# 1969 - 1976 Corvette: Service Bulletin: Air Conditioning Compressor Drive Belt to Radiator Hose Interference

**Subject:** Air Conditioning Compressor Drive Belt to Radiator Hose Interference

**Model and Year:** 1976 and Past Model Corvette Equipped with the 350 Cubic Inch Engine and Air Conditioning

**Bulletin Number:** 76-T-21, Section VI - (May 1976)

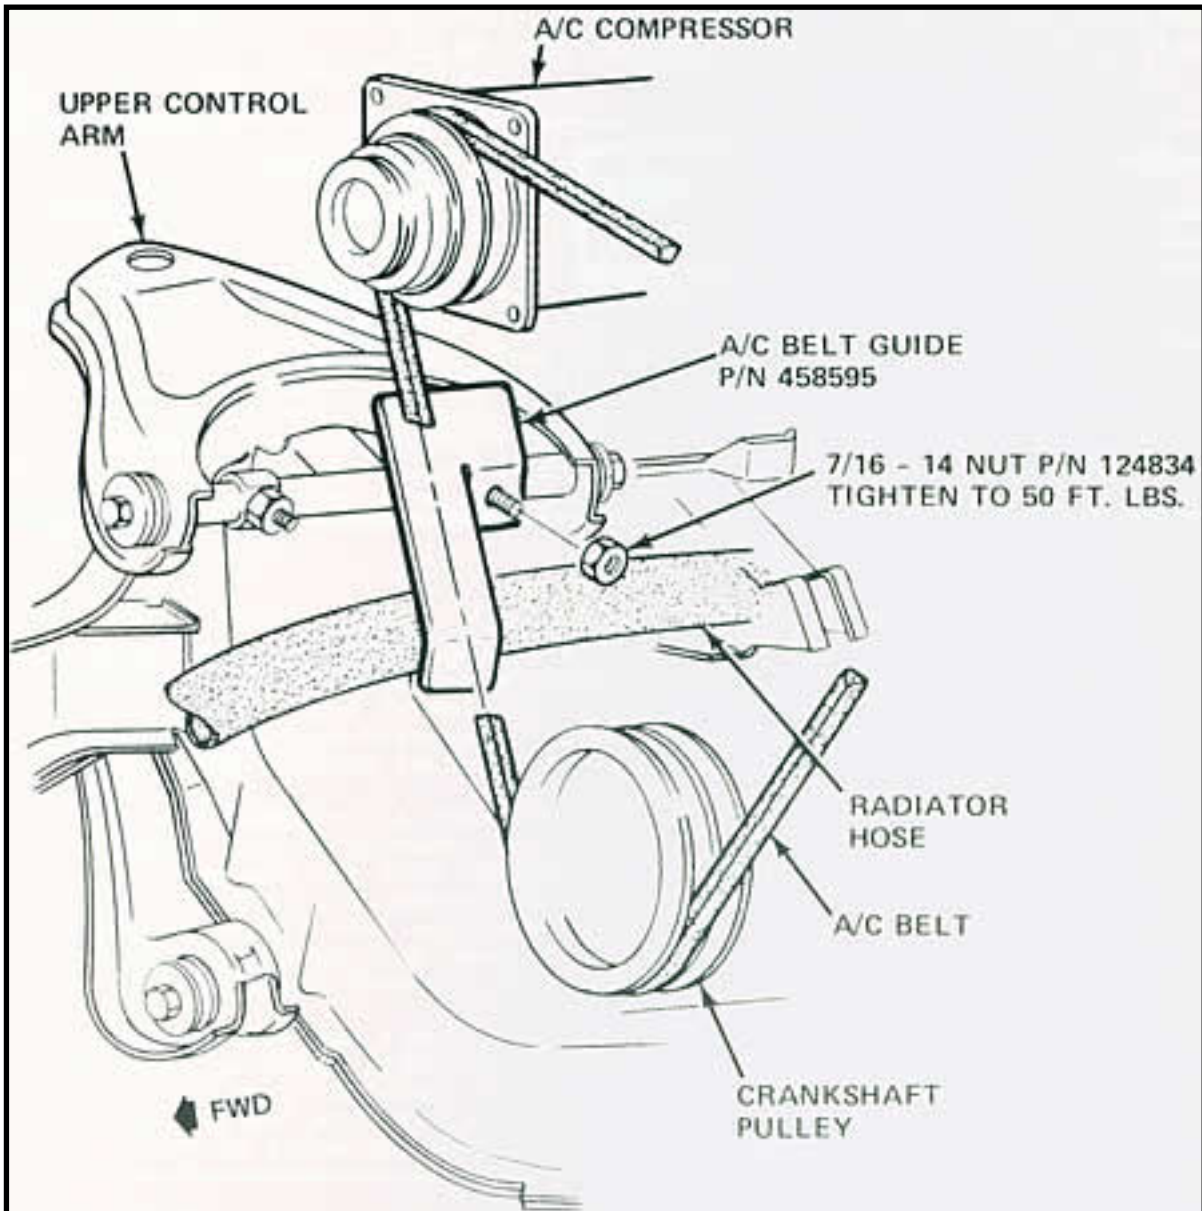
Some 1976 and past model Corvettes equipped with the 350 cubic inch engine and air conditioning may experience an interference condition between the radiator outlet (lower) hose and the air conditioning compressor drive belt. This belt chafing condition could damage the hose and may cause eventual coolant loss.

Belt to hose interference has been eliminated by installing a belt guide, part number 458595, at the assembly plant. This guide is mounted over the rear attaching bolt for the upper right side control arm. The guide is between the belt and hose and prevents the belt from chafing the hose (see illustration on the following page). The belt guide went into production on vehicle identification number 6S416060 December 18, 1975.

This condition can be corrected on past model and vehicles built prior to the VIN cutoff by installing the belt guide as shown on the illustration. The belt guide can be obtained from GMPD. Use nut, part number 124834, to attach guide over the top of the existing rear upper control arm nut and torque to 50 ft.-lbs.
